### **ISLAND LAKE NORTH BAY TREE REMOVALS JSP21-23**

Matter of Consideration at the request of Elliott Milstein, President of Island Lake North Bay Homeowner's Association, for approval of a Revised Landscape Plan. The subject property contains 22.1 acres and is located in Section 18 & 19, east of Napier Road, north of Seaglen Drive. In this revised request, the applicant is proposing to remove 37 landscape trees within open space common area of the Island Lake North Bay Homeowner's Association (Phase 6 of Island Lake) due to tree health, site congestion, and aesthetics.

**PLAN REVIEW CENTER REPORT**  
**Planning Review**  
**ISLAND LAKE NORTH BAY TREE REMOVALS – 1<sup>st</sup> Revision**  
JSP 21-23  
October 1, 2021

**PLAN REVIEW CENTER REPORT**  
**October 1, 2021**  
**Island Lake North Bay Condos Tree Removals**  
**Revised Landscape Plan Review**

**TREE REPLACEMENT PLAN  
PROVIDED BY CITY  
LANDSCAPE ARCHITECT**

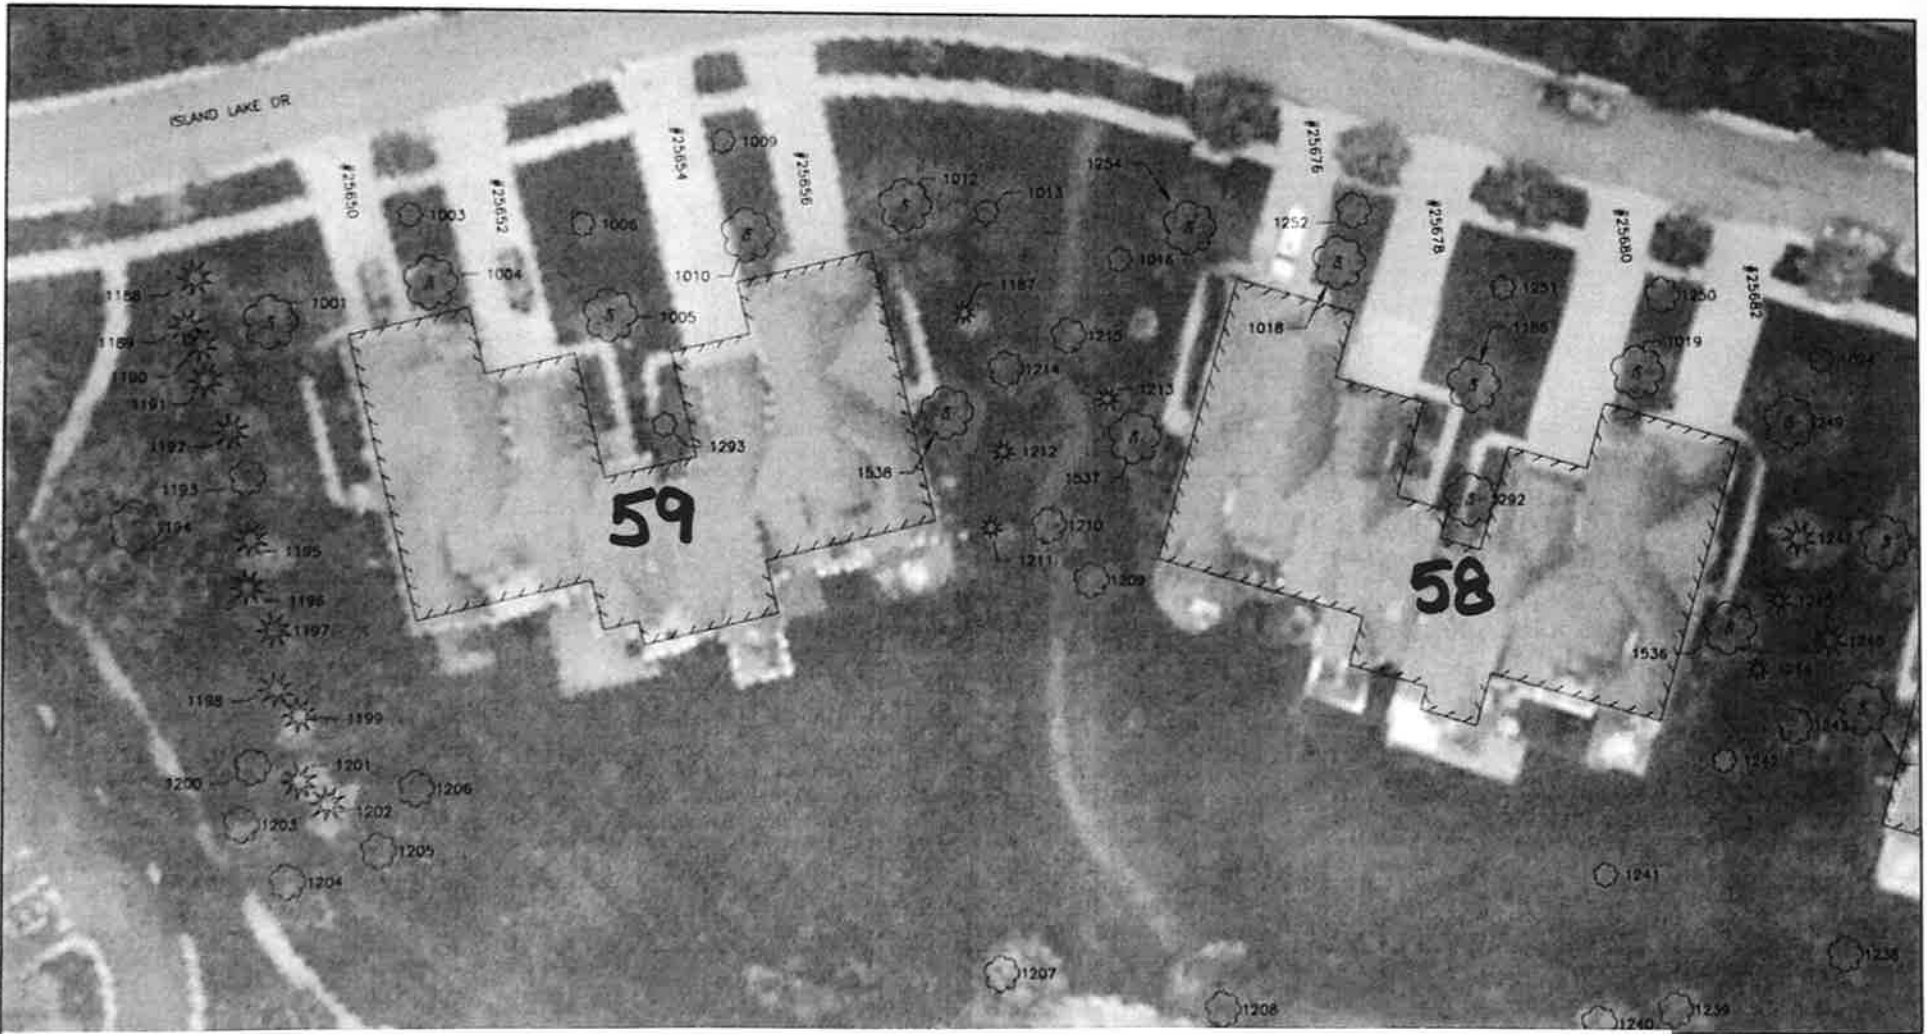
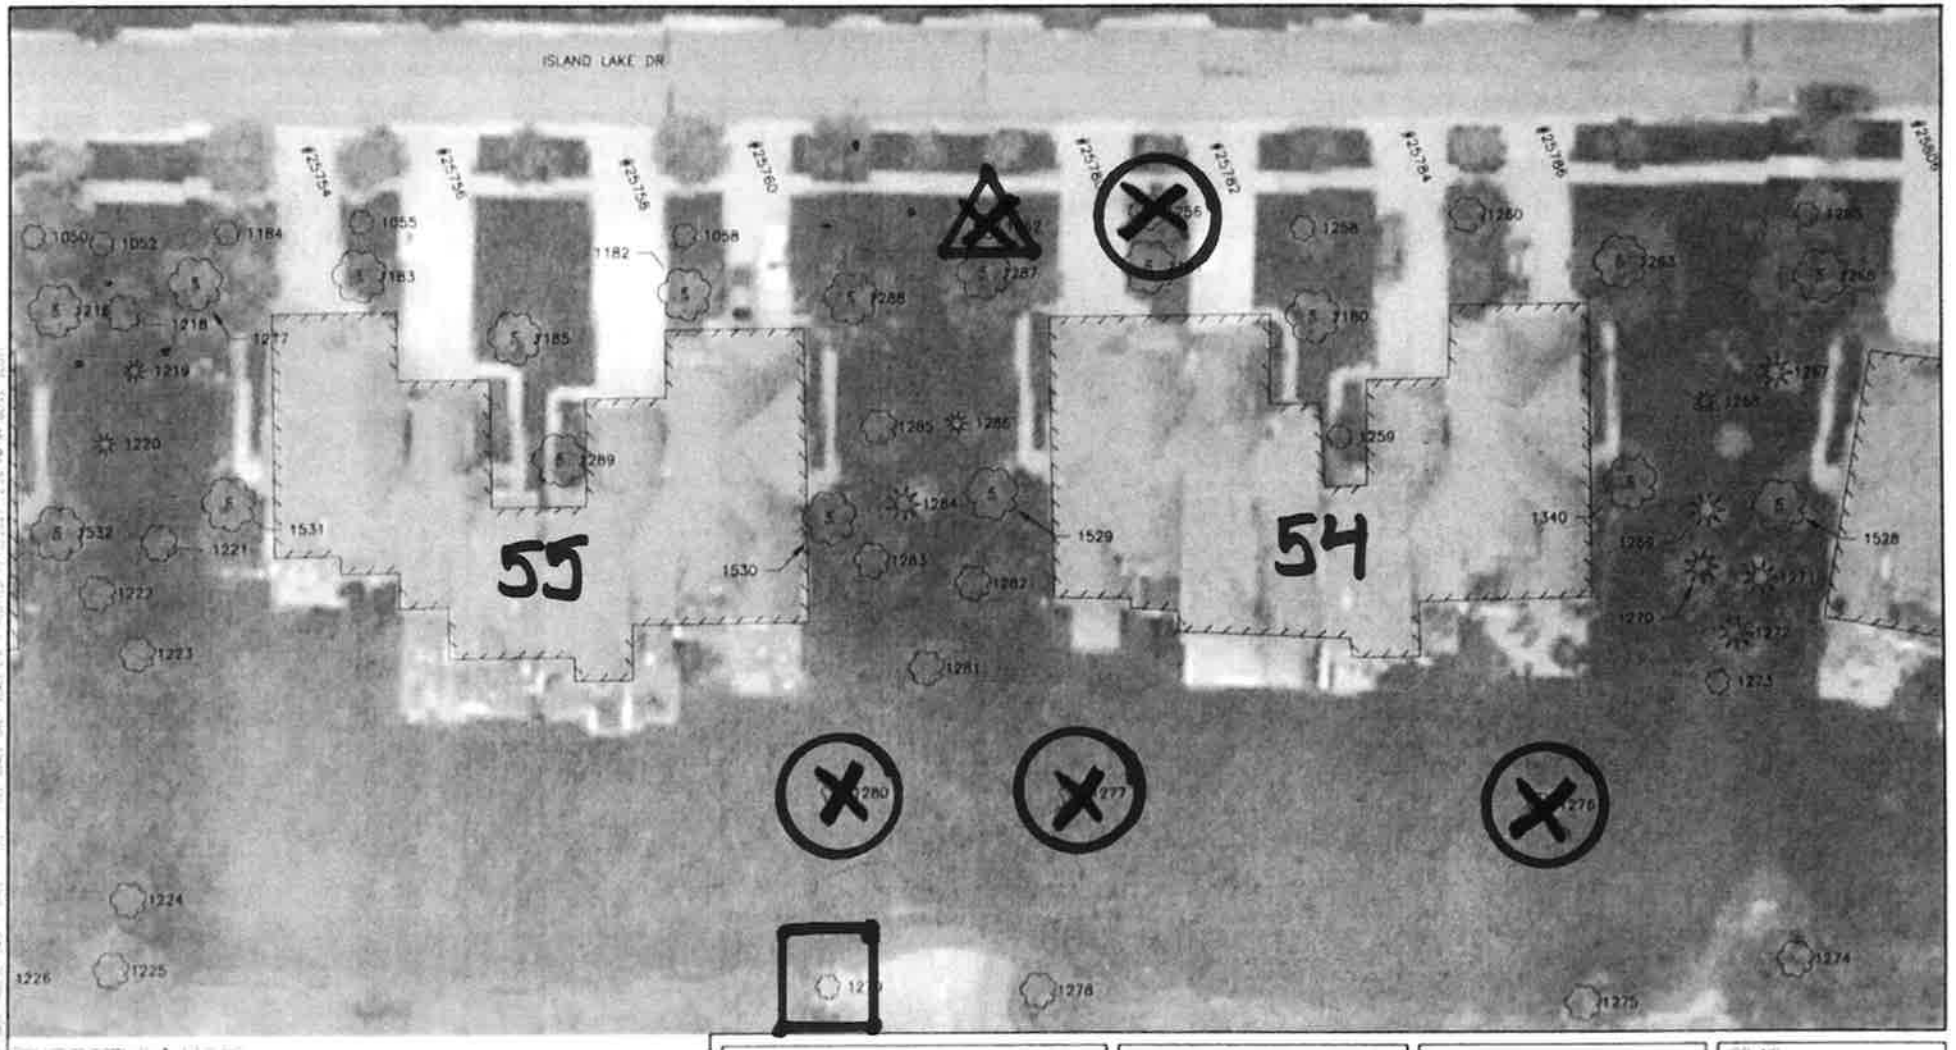
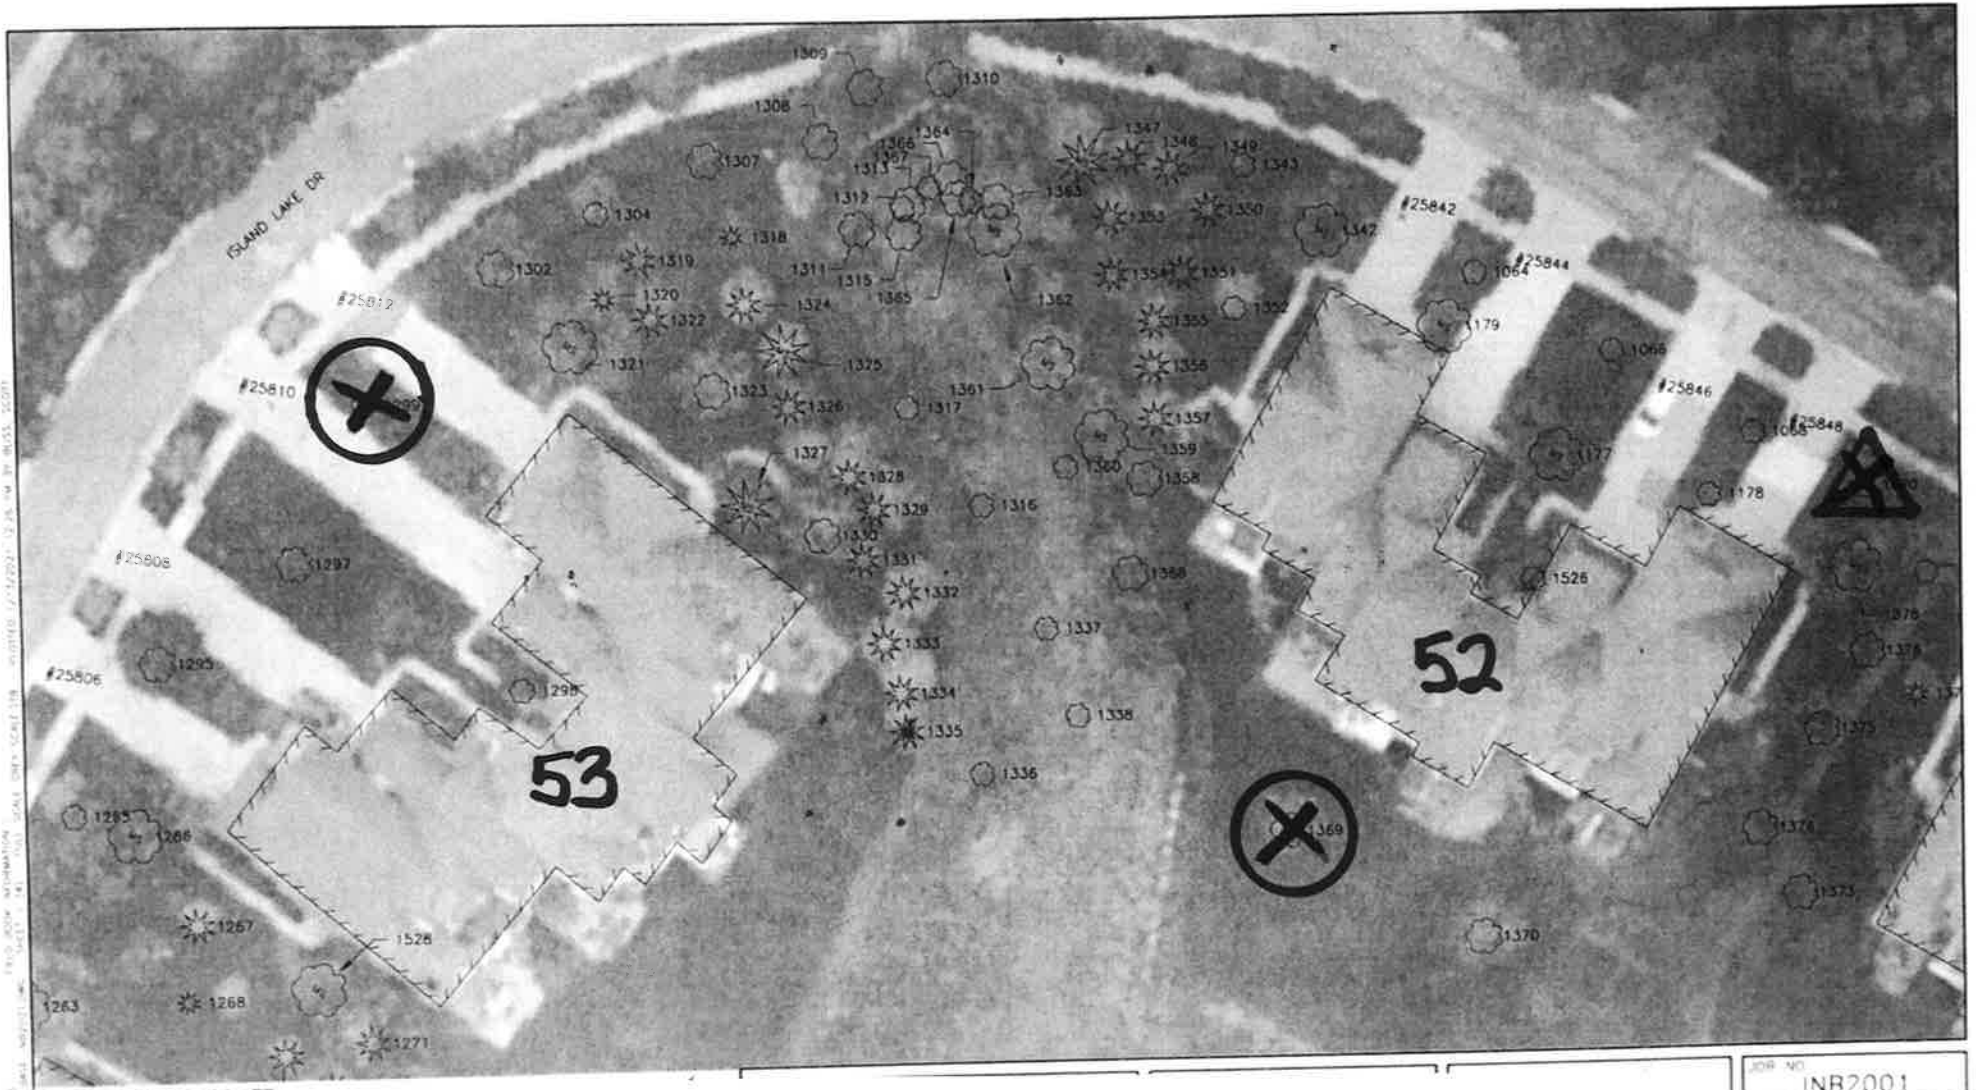
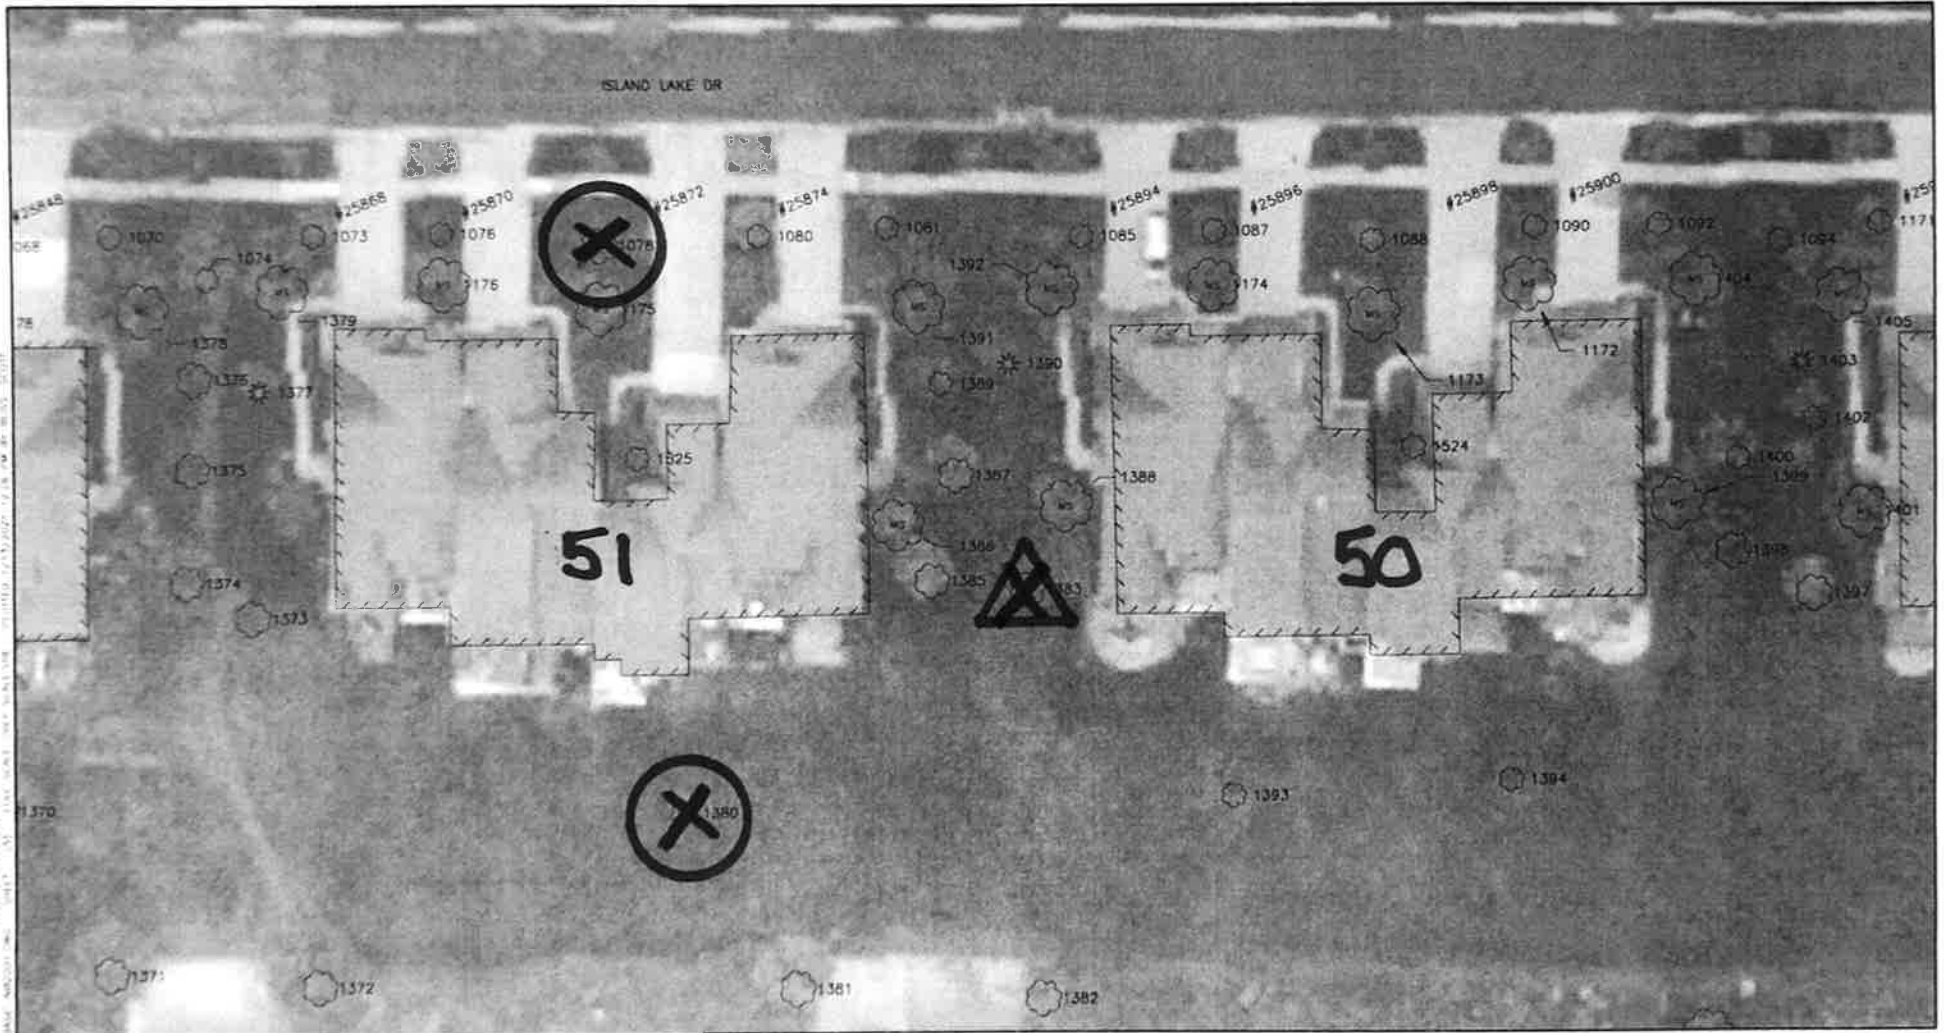
- CIRCLE:** Trees not shown on any plan, may be removed without replacement 15 trees
- TRIANGLE:** Trees on a plan that staff recommends for removal without replacement 14 trees
- SQUARE:** Trees on a plan that staff does not recommend for removal without replacement 8 trees

Staff's recommendation is to (1) allow the applicant to remove 29 trees without replacement, and (2) either don't allow removal of the remaining 8 trees, or, if the Commission does allow those 8 to be removed, to require replacement. (To be more specific, only 7 of these 8 trees are technically proposed for removal. One of the 8 is already missing, and therefore staff is recommending it be replaced.)

- **15 trees not on any plan—allow with no replacement.**

All trees <b>not</b> on a plan approved for removal without replacement:	15 trees
Trees on a plan that staff supports removing without replacement:	
• Between Units 57 and 58:	1 tree
• Between Units 56 and 57:	1 tree
• Near street between Units 55 and 56:	1 tree
• Near street between Units 54 and 55:	1 tree
• Between Units 50 and 51:	1 tree
• Near street between Units 51 and 52:	1 tree
• Near street between Units 48 and 49:	2 trees
• Between Units 48 and 49:	1 tree
• Between Units 47 and 48 (on lake side):	1 tree
• Near street between Units 46 and 47:	2 trees
• Between Units 45 and 46	1 tree
• <u>Between Units 45 and 45</u>	<u>1 tree</u>
	14 trees

**As mentioned above, there is 1 shoreline tree behind Unit 55 that has been removed but was not included in the proposal. That tree should be replaced as it was on the shoreline plan and serves important aesthetic and ecological function.**
